Re: On-Going Services  
Drainage Review of 25 Windermere – **New Pool, First Revision, Third Submittal**  
Piney Point Village, Texas  
HDR Job No. 10361768

We are in receipt of the proposed drainage plan for the above referenced address, with engineer seal dated 3/22/2023. Please make the following changes to the drainage plan:

PROPOSED POOL, SPA, & DECK  
AT  
25 WINDERMERE LN.  
HOUSTON, TEXAS 77063

DRAINAGE PLAN	
JOB NO:	22-373
CHECKED BY:	JV
DRAWN BY:	RM
DATE:	03/22/2023
SCALE:	AS SHOWN
DRAWING TITLE:	
DRAINAGE PLAN	
DRAWING NO.	
C-2

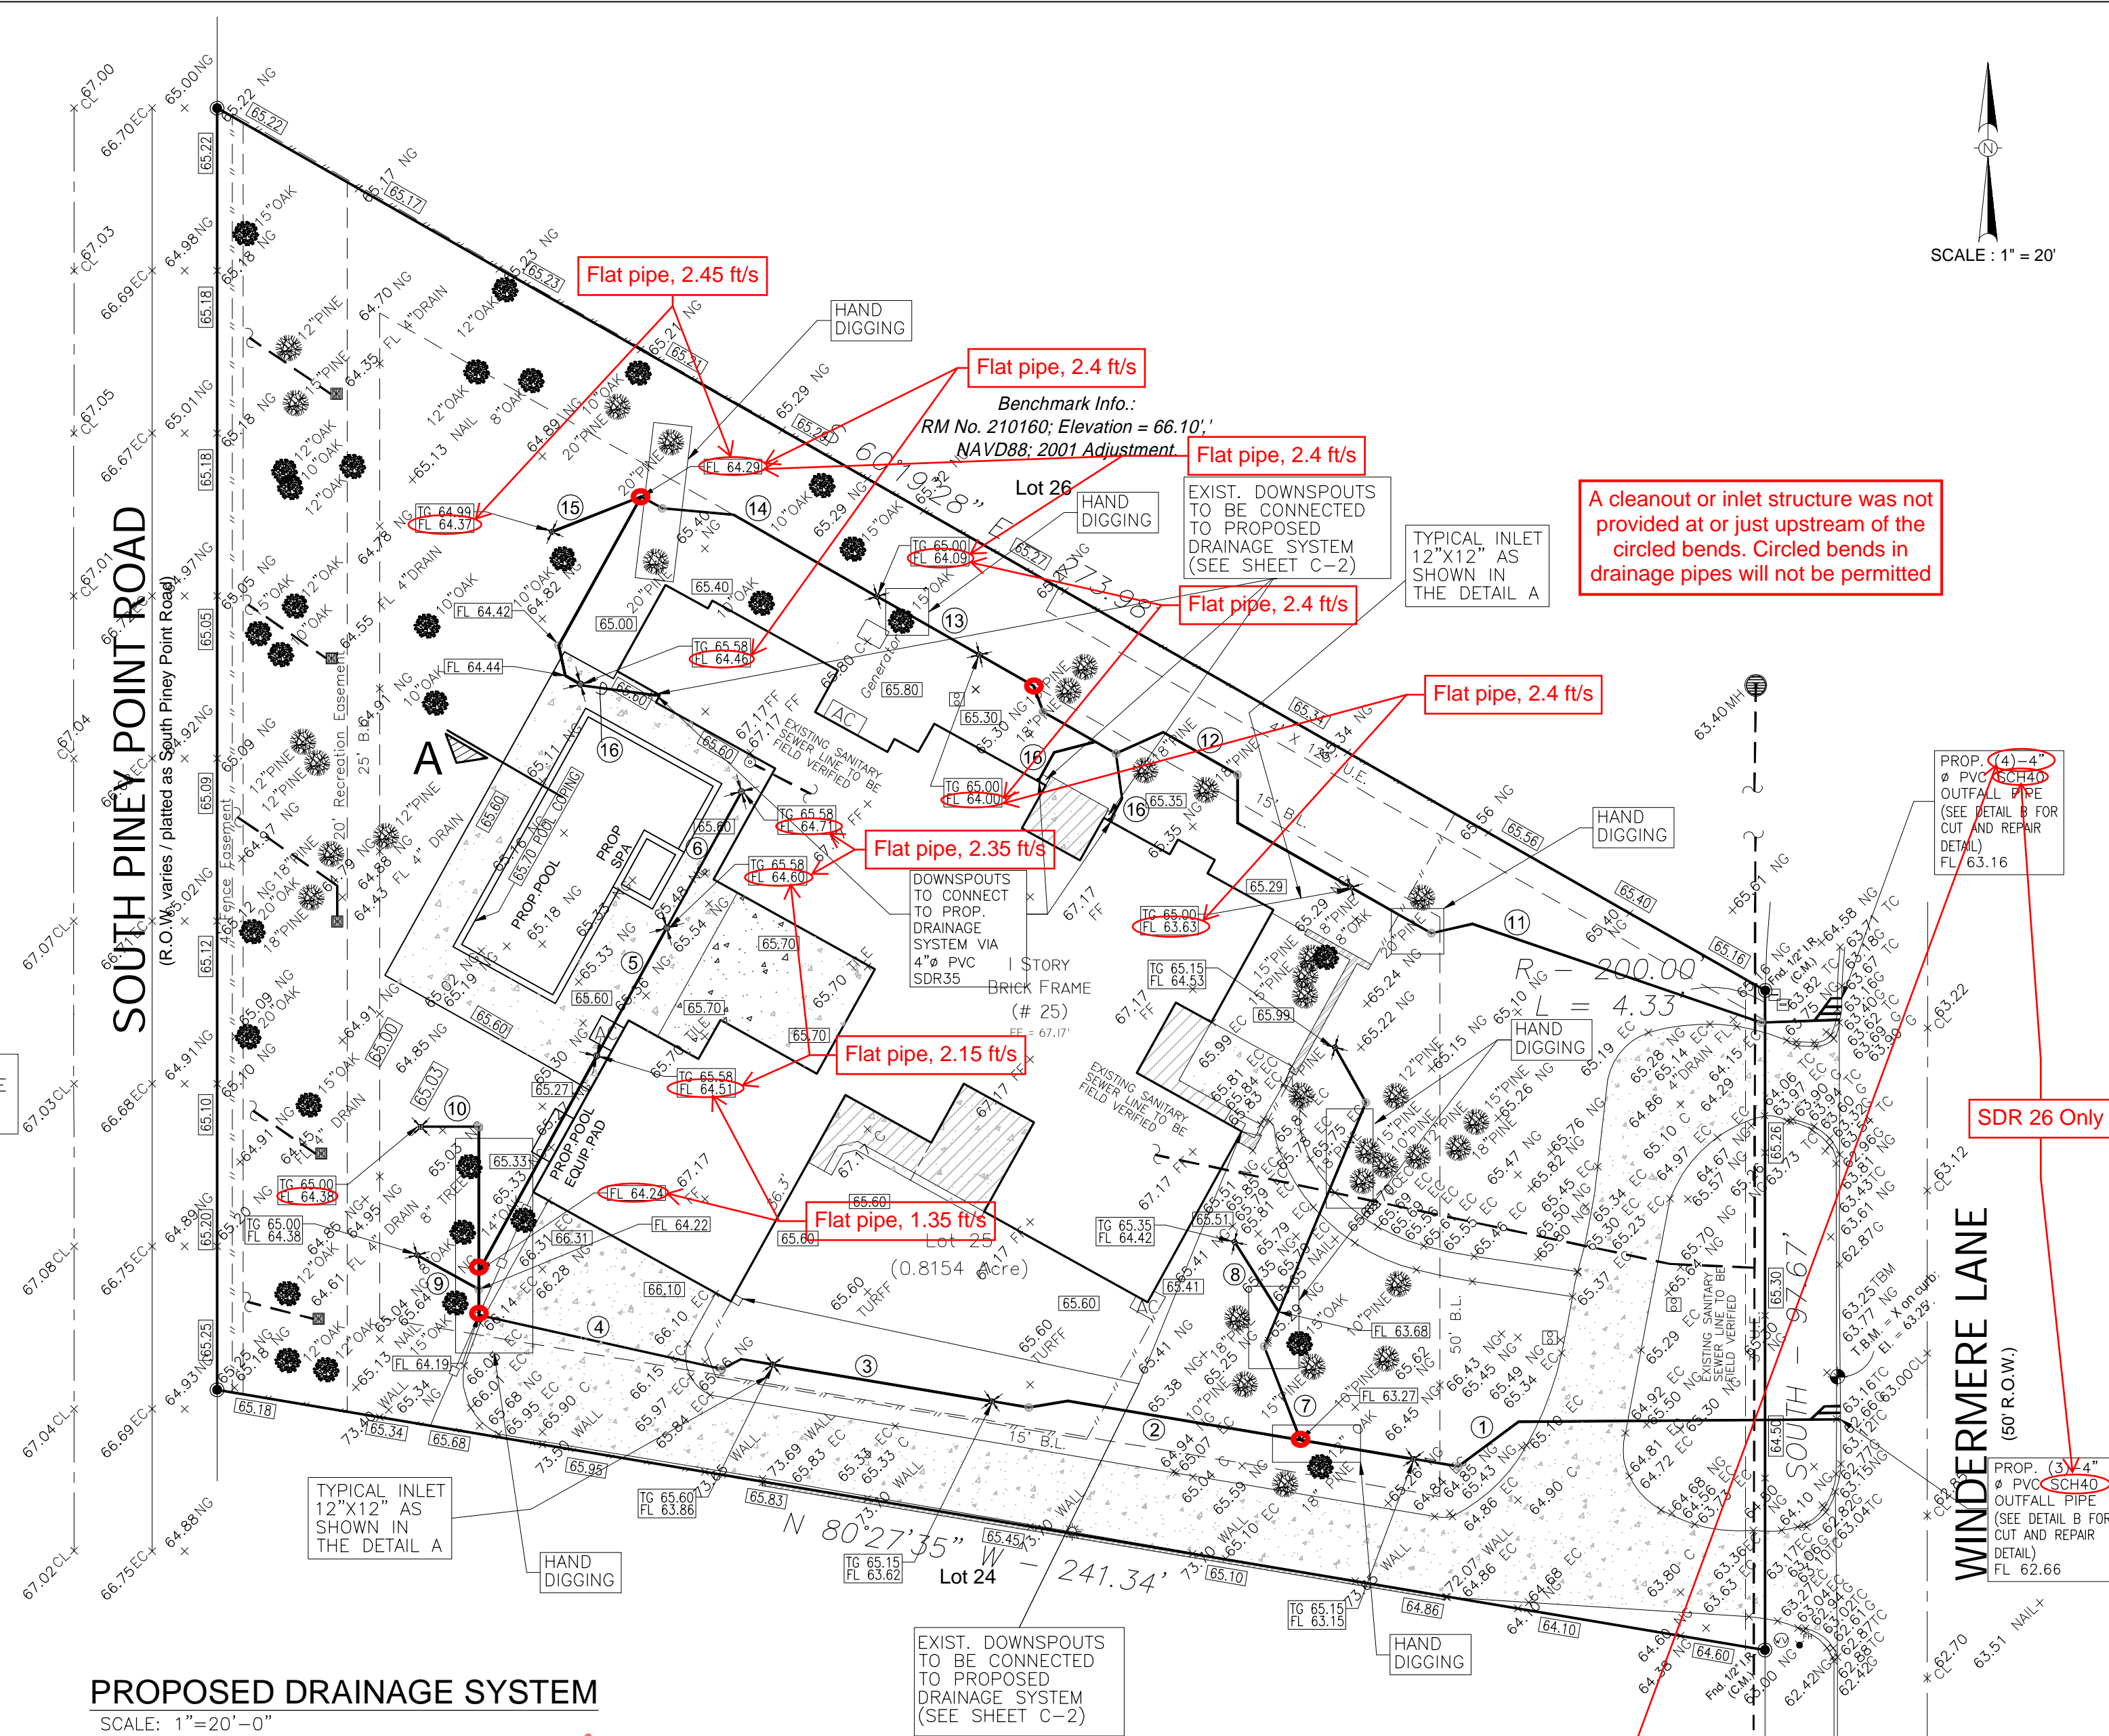
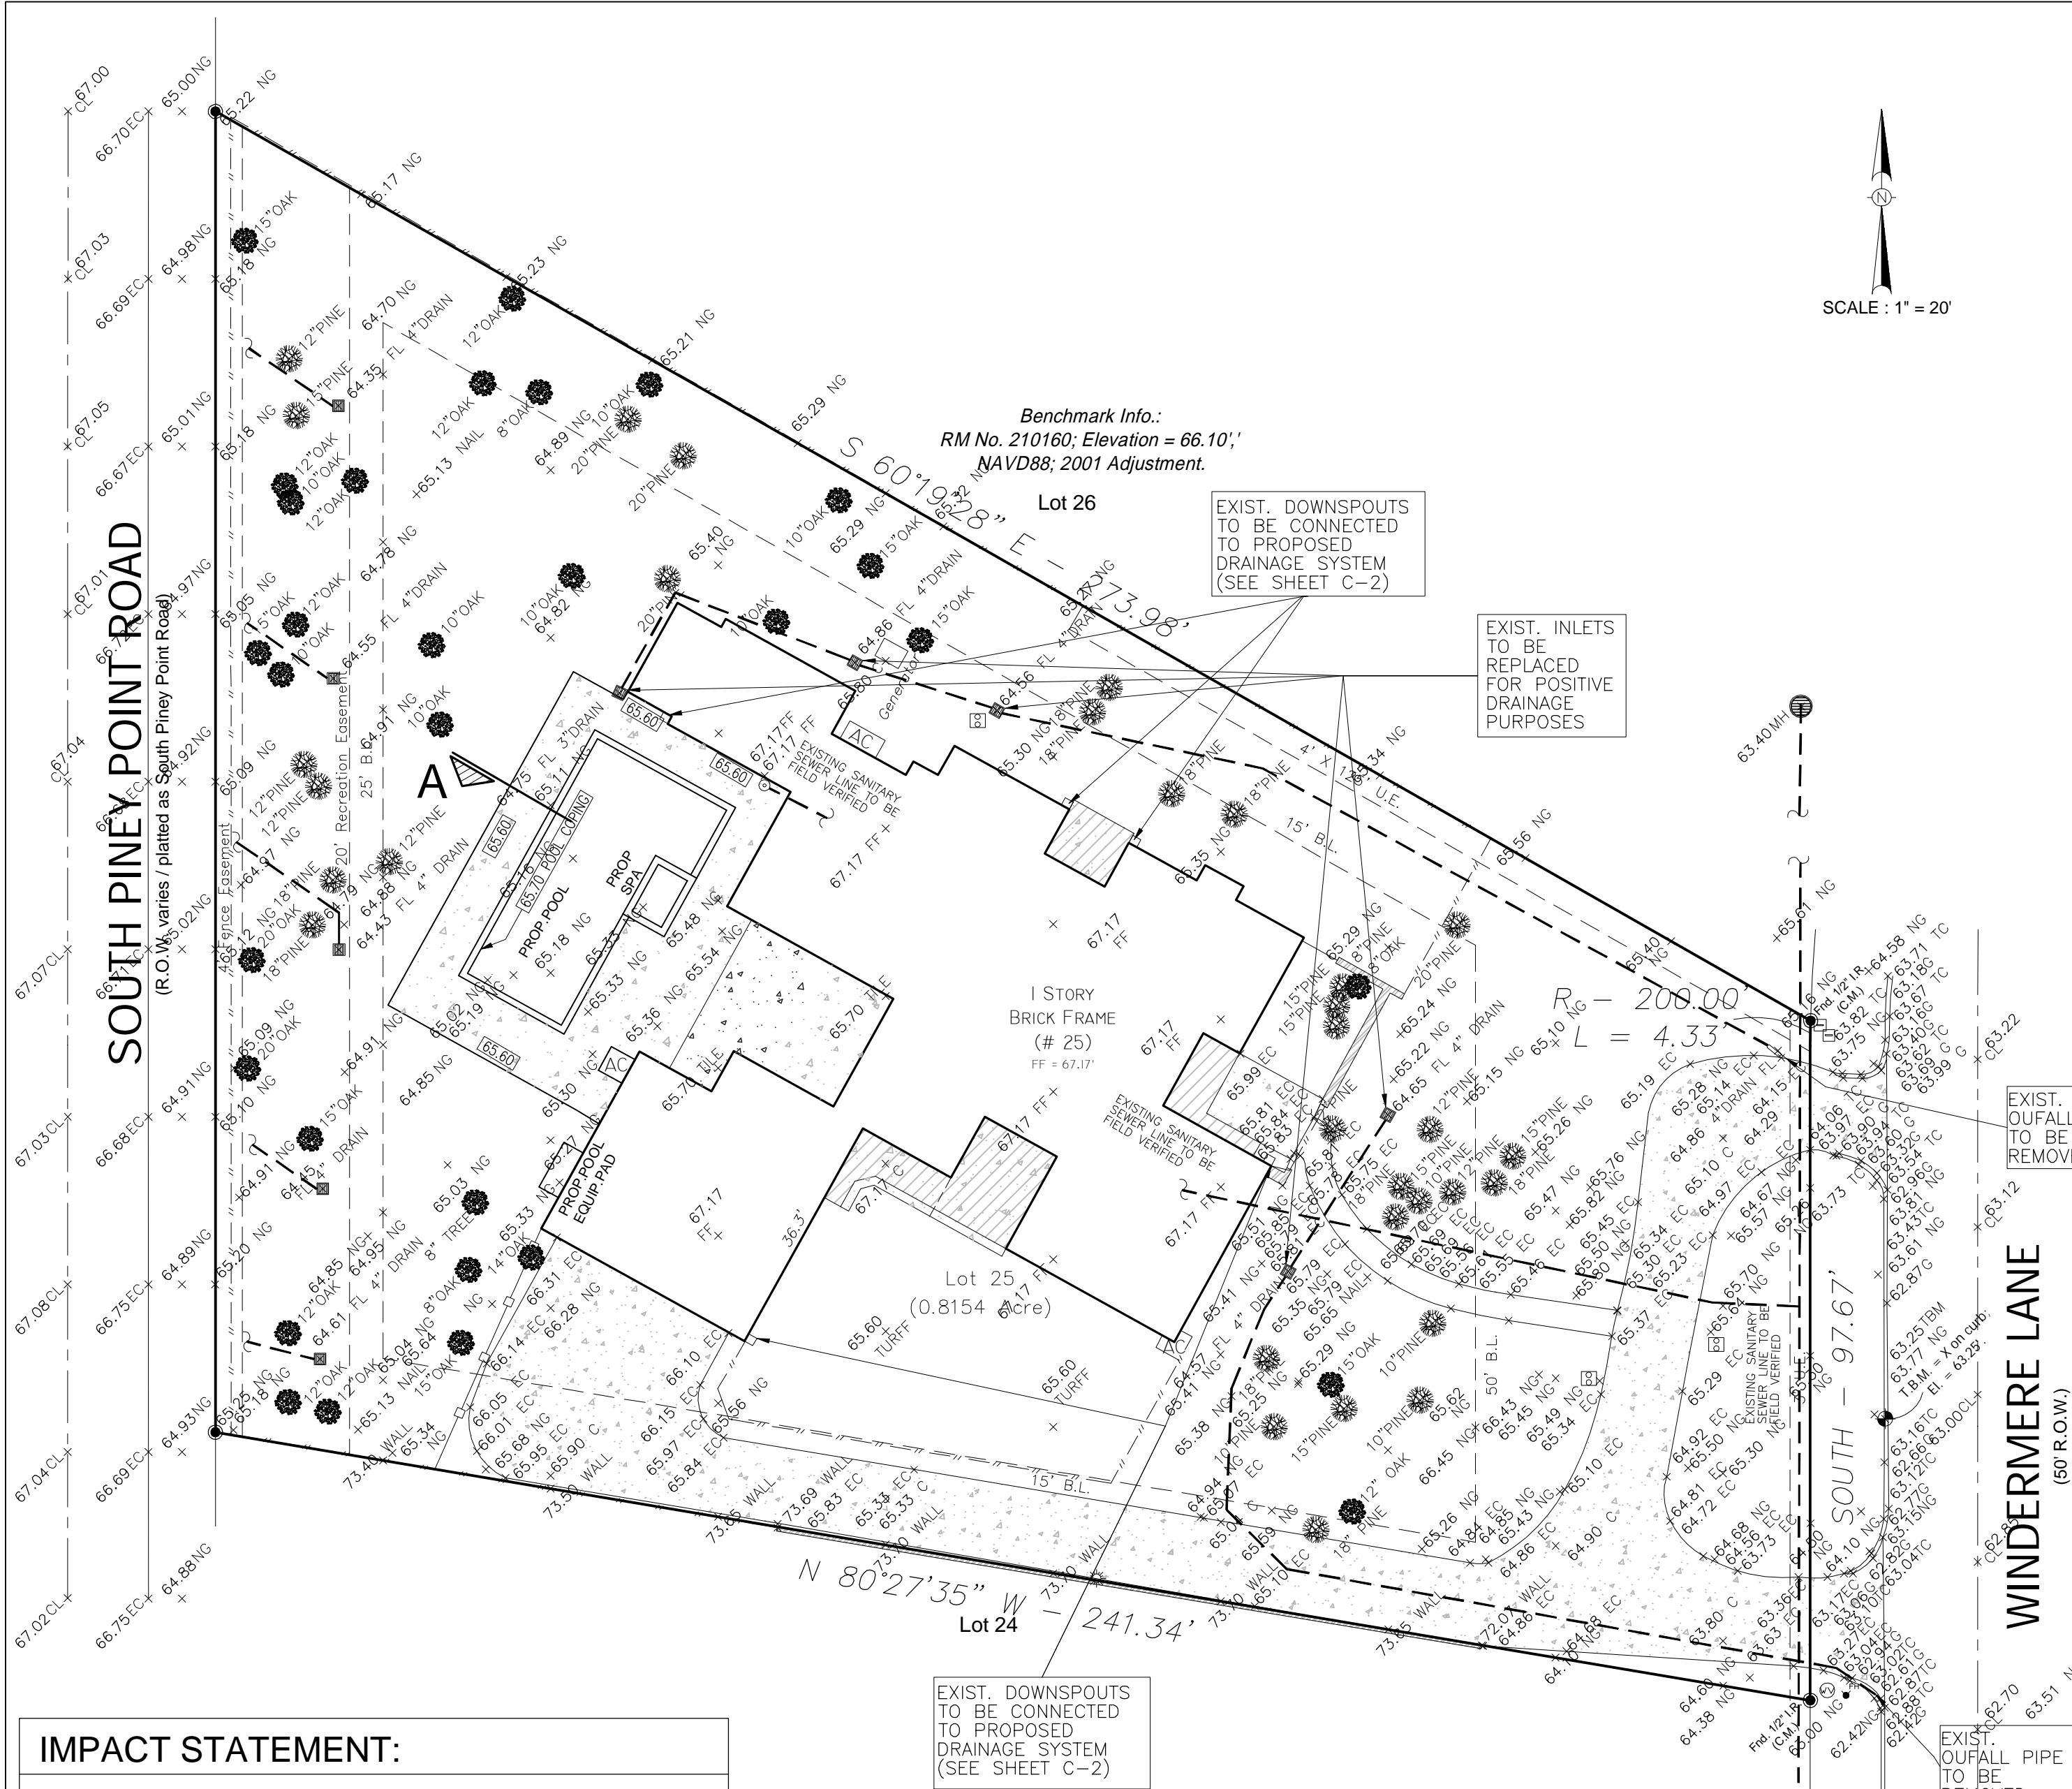
1. Per City drainage criteria and our letters dated 2/22/23 and 3/15/23, the drainage system must include a clean-out, inlet, or junction box at every bend so as to provide access for maintenance; the only exception may be where roof drains tie into the main system. It appears there are several locations of proposed bends in the pipe that do not have a clean-out, inlet, or junction box **at the bend or on the upstream bend of a pair of bends in pipe**. Please revise the drainage plan to ensure this criterion is met.

2. Per City drainage criteria and our letters dated 2/22/23 and 3/15/23, all proposed drainage pipes shall be sloped to achieve a velocity of at least 3ft/sec. Based on flowline elevations, it appears that there are eight proposed pipes that are not adequately sloped to achieve a velocity of at least 3ft/sec. Please revise the drainage plan to ensure that all proposed pipes are sloped for a velocity of at least 3 ft/sec to ensure this criterion is met.

3. Per City drainage criteria and our letter dated 3/15/23, if storm sewer pipes are proposed in drainage plan, main pipes shall be minimum 6" PVC SDR 26. It appears that the 4-inch outfall pipes on the property are proposed to be Schedule 40. Please revise the drainage plan to ensure this criterion is met.

4. It appears that the proposed pool, spa, and deck cross section shows elevations that do not match the proposed pool, spa, and deck elevations shown on the drainage plan. Please verify the correct proposed elevations and revise the drainage plan so that the proposed elevations on the cross section match the elevations proposed on the drainage plan.

5. It appears that the “Proposed Curb Cut & Repair Detail @ Single Pipe Outfall” detail on the drainage plan shows two 4-inch pipes outfalling through the curb into the street while the drawing shows one location with three 4-inch pipes and another location with four 4-inch pipes outfalling into the street. Please revise the detail on the drainage plan to reflect the actual number of 4-inch pipes at each outfall location into the street.
